Access Compliance Report Public Rights-of-Way (Curb Ramps)

Main Street: WENDOVER_RD Cross Street: SHADOW_HILL_DR Location: SE

ADA ID: RPAT210922141732 Ramp Type: Type 1 - Perpendicular Diagonal Initial Pass/Fail: Pass Overall Compliance: No Severity Score: 19

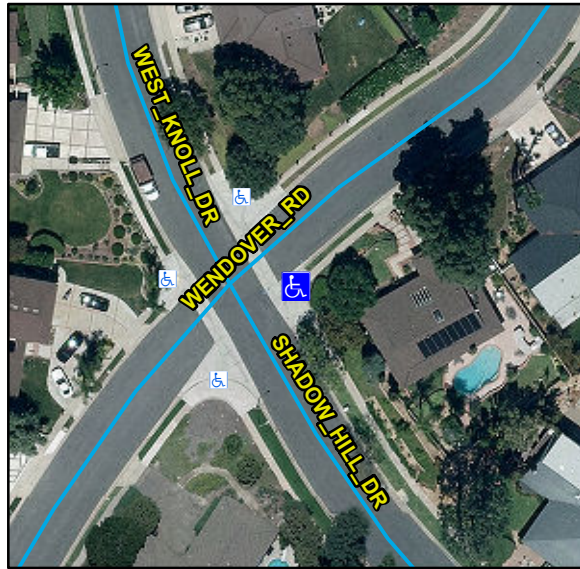
R304.2.2, R304.5.3, R304.2.1, STD 1115

Remove & Replace Curb Ramp With Two New Directional Ramps or Equivalent. Remove & Replace Gutter.
